PRODUCT / PROCESS CHANGE NOTIFICATION

STMicroelectronics International N.V
1.2 PCN No.		AMS/15/9519
1.3 Title of PCN		Additional back end capacity for TSSOP16 package in Nantong Fujitsu for AMS products
1.4 Product Category		Selected VMA products in TSSOP16 package (see product list)
1.5 Issue date		2015-11-20

PCN AMS/15/9519

Additional Back End capacity in Nantong Fujitsu for AMS products in TSSOP16 package

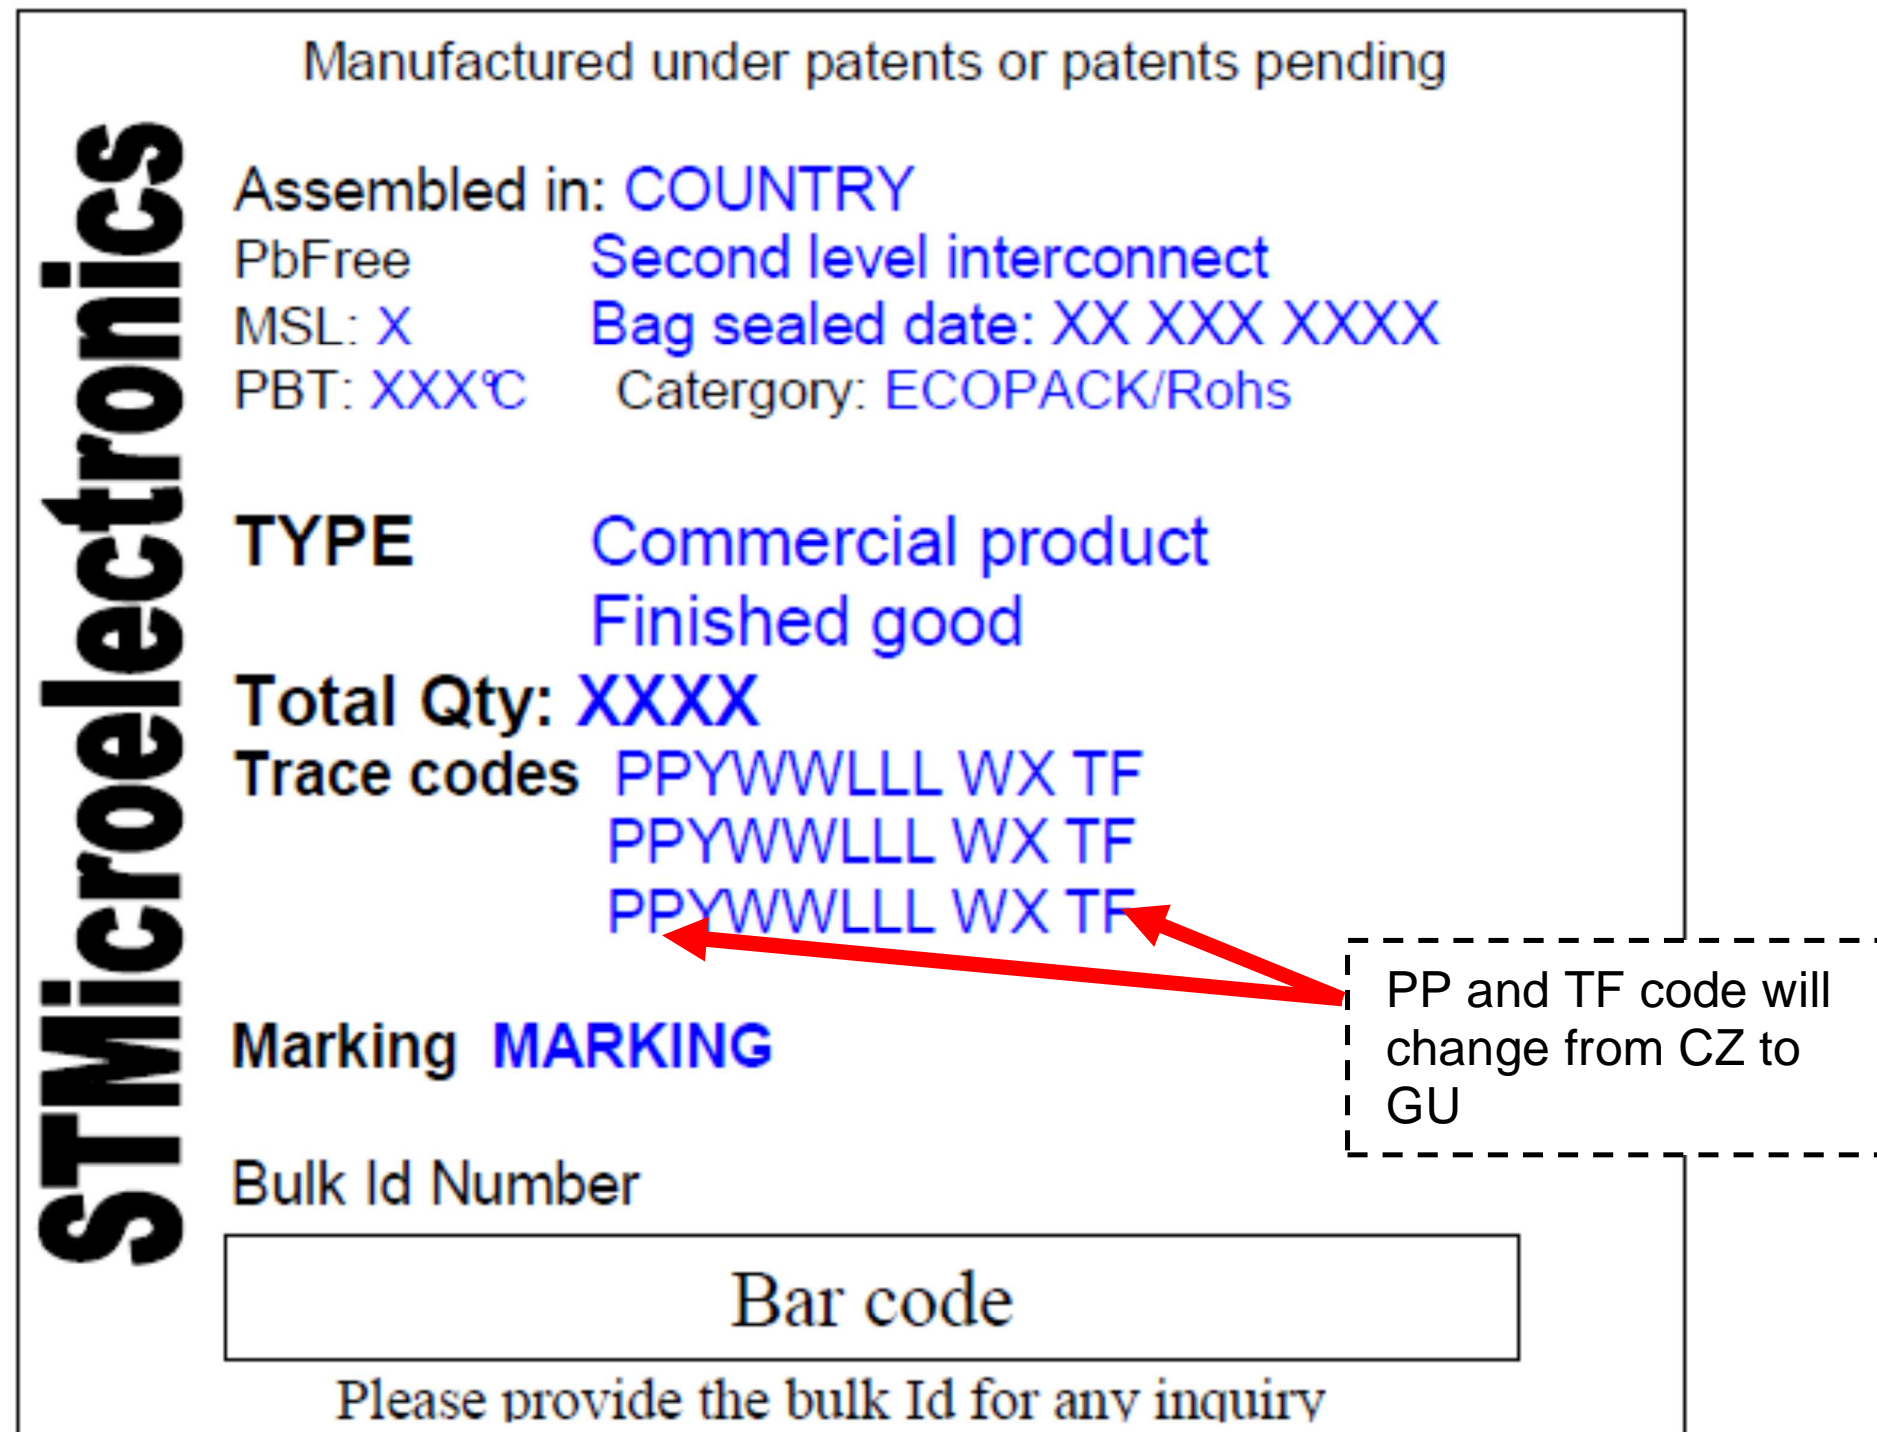
Marking and traceability:
Unless otherwise stated by customer specific requirement, the traceability of the parts assembled in Nantong Fujitsu will be ensured by marking on package and on label as per below description:

MSL: Moisture sensitivity level as per Jedec J–std-020C
PBT: Peak body temperature (maximum temperature for reflow soldering)
ECOPACK: present if leadfree component
TYPE: product name
Trace codes:
- PP: assembly plant code
- Y: last digit of the year of assembly
- WW: Week of assembly
- LL1: lot number
- WX: Diffusion plant code
- TF : Test&finishing plant code

Bulk ID number:
- 1: Product level (T for tested product)
- Y: last digit of the year
- P: Plant code
- WW: Week of labeling
- LOT: Sequential number for lot
- BOXX: Sequential number for box
